**SHAWNEE MISSION DISTRICT LIGHTING UPGRADES 2021**

Indian Hills MS, Northwest HS, West HS, East HS  
**HTK PROJECT NO. 1707.05-004**

**CONTRACT ADDENDUM NO. 2**  
**March 26, 2021**

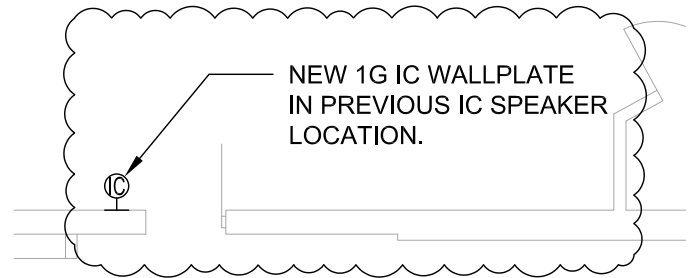
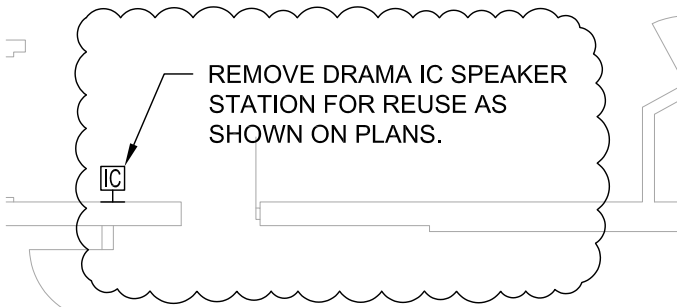
G101: At new speaker openings, provide Guilford of Maine FR701 in lieu of previous note for FR702. Color to be selected from manuf. full range.

SHEET NO. AD01

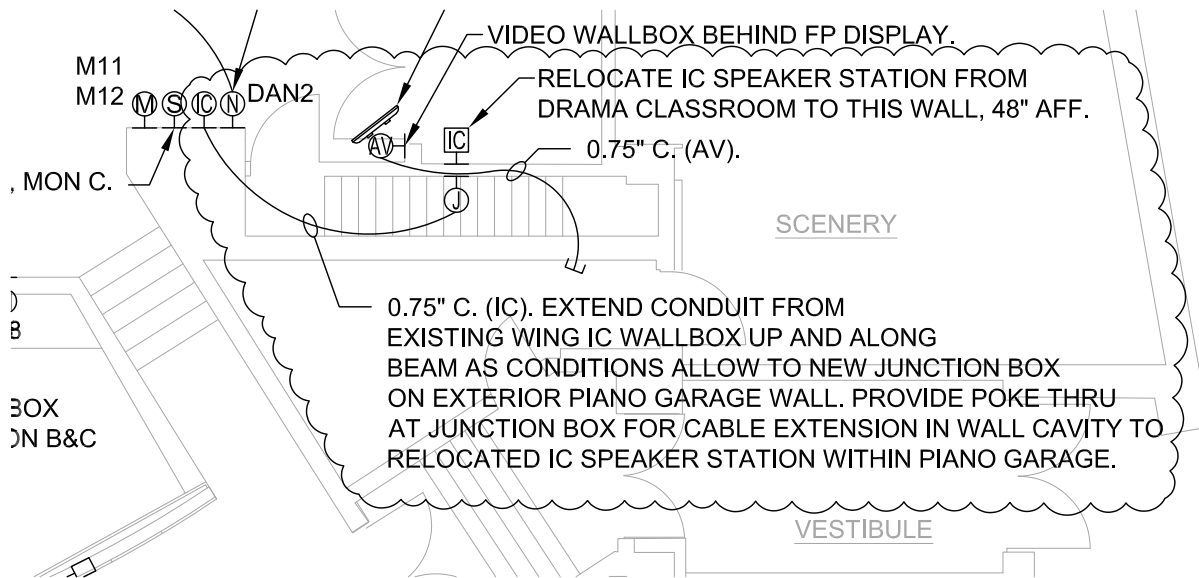
SM East Auditorium– The existing Drama Classroom intercom speaker station is to be relocated to the Piano Garage (Stage Left) per instructions on attached drawing AD01.
